Contract #: 04-0120F4Cty: SF/ALA Rte: 80 PM: 13.2/13.9File #: 69.25B**QUALITY ASSURANCE -- NON-CONFORMANCE REPORT****Location:** Changxing Island, Shanghai, P.R. China**Report No:** NCR-000558**Prime Contractor:** American Bridge/Fluor Enterprises, a JV**Date:** 22-Dec-2009**Submitting Contractor:** Zhenhua Port Machinery Company, Ltd (ZPMC), Changxing Island**NCR #:** ZPMC-0531**Type of problem:**

**Reference Description:** Side Panel Flatness, L5E**Description of Non-Conformance:**

**DEPARTMENT OF TRANSPORTATION - District 4 Toll Bridge**

## NCR PROPOSED RESOLUTION

HSR(B)-351

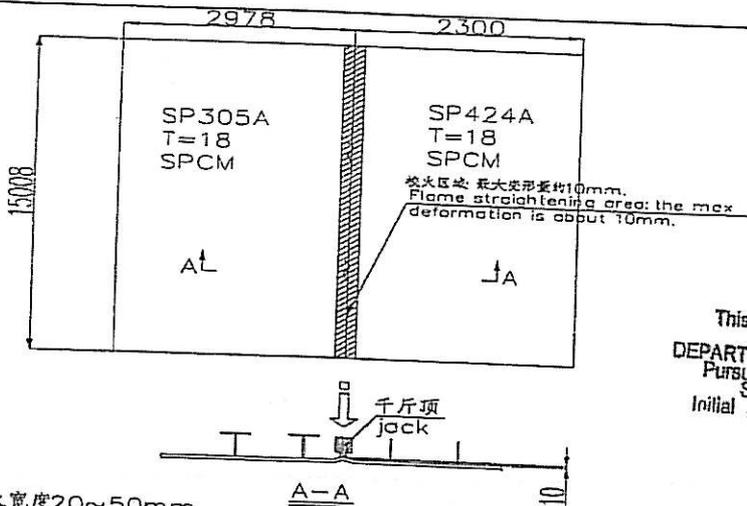
梁段 Gird: 5BE SP305A+SP424A

Cause原因 Welding distortion 焊接变形

Using hand torch and Jack, Jack shall be used in a manner such that all forces are applied passively.  
使用火焰枪以及千斤顶进行校火,千斤顶只能起到固定作用不能产生塑性变形。

1. Remove paint and perform 100%VT, MT & UT on welds in heat straightened areas.  
将校火区域的油漆移除,并对此区域进行100%VT, MT和UT. AFTER HEAT STRAIGHTENING
2. Jacking shall not be used to plastically deform the flange. The Jack shall only be used as a fixture. After finishing heat straightening, the weld of the heat area shall perform NDT according to the approved shop drawing.  
不能使用千斤顶进行塑性变形,千斤顶只能用作固定装置。校火后需按照图纸上的要求对热影响区域进行NDT检测。

Increase the flange anti-deformation allowance during the course of fit-up, and Control the welding parameters according to associated WPS. 在装配的过程中增加反变形余量。根据相关WPS控制焊接参数。

HSR(B)-352

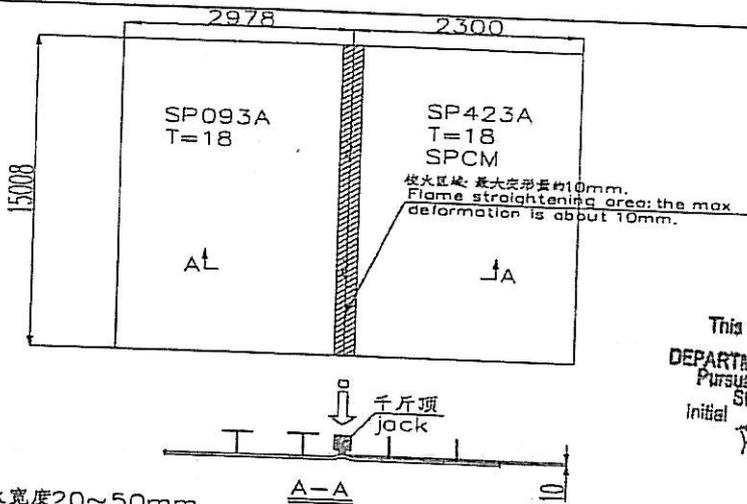
5AE

SP304A+SP423A

Welding distortion 焊接变形

Using hand torch and Jack, Jack shall be used in a manner such that all forces are applied passively. 使用火焰枪以及千斤顶进行校火,千斤顶只能起到固定作用不能产生塑性变形。

1. Remove paint and perform 100%VT, MT & UT on welds in heat straightened areas. 将校火区域的油漆移除, 并对此区域进行100%VT, MT 和 UT. AFTER HEAT STRAIGHTENING
2. Jacking shall not be used to plastically deform the flange. The Jack shall only be used as a fixture. After finishing heat straightening, the weld of the heat area shall perform NDT according to the approved shop drawing. 不能使用千斤顶进行塑性变形。千斤顶只能用作固定装置。校火后需按照图纸上的要求对热影响区域进行NDT检测。

Increase the flange anti-deformation allowance during the course of fit-up, and Control the welding parameters according to associated WPS. 在装配的过程中增加反变形余量。根据相关WPS控制焊接参数。

The heat straightening width is about 20~50mm.

HSR(B)-8146

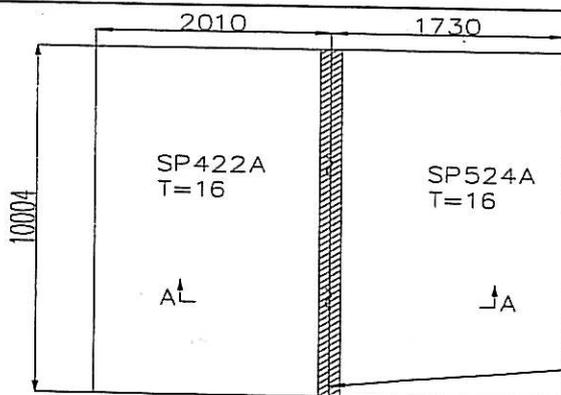
梁段 Gird: 5CE

Welding distortion 焊接变形

Flame Straightening by oxygen-acetylene 运用氧乙炔进行校火

After finishing heat straightening, the weld of the heat area shall perform NDT according to the approved shop drawing 校火后, 根据图纸要求对热影响区域进行 NDT 检测。

Control current, voltage and weld speed according to relevant WPS. If necessary anti-deformation or hold down device can be added. 依据相应的WPS的要求控制电流, 电压和焊接速度。如有必要, 可使用反变形设施进行校正。

校火区域: 最大变形量约10mm.  
Flame straightening area; the max deformation is about 10mm.

HSR1(B)-8128

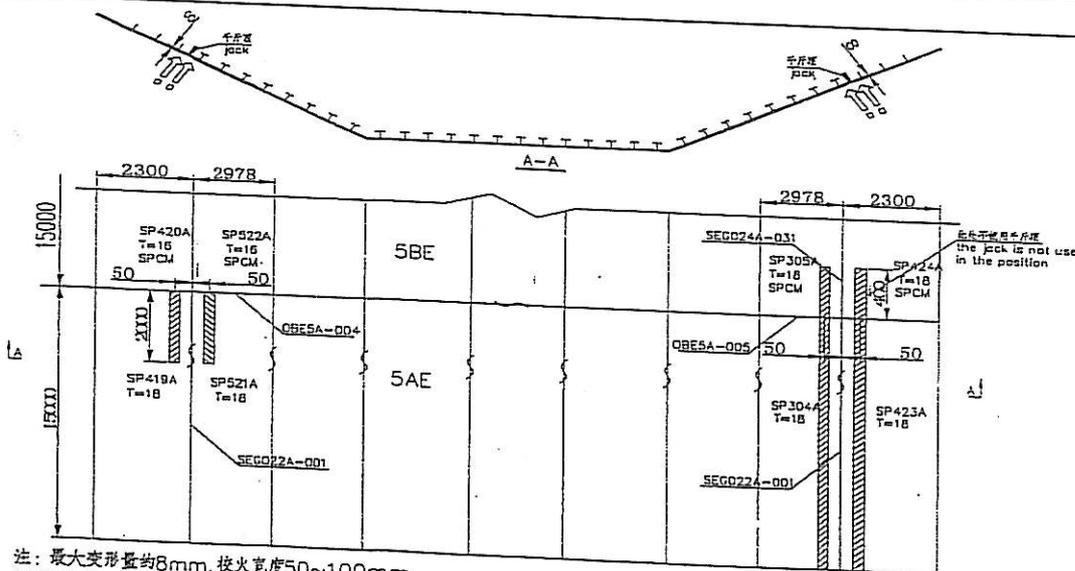
梁段 Gird: 5AE- 5BE

Welding distortion 焊接变形

Flame Straightening by oxygen acetylene 运用氧乙炔进行校火

After finishing heat straightening, the weld of the heat area shall perform NDT according to the approved shop drawing 校火后, 根据图纸要求对热影响区域进行 NDT 检测。

Control current, voltage and weld speed according to relevant WPS. If necessary anti-deformation or hold down device can be added. 依据相应的 WPS 的要求控制电流, 电压和焊接速度。如有必要, 可使用反变形设施进行校正。
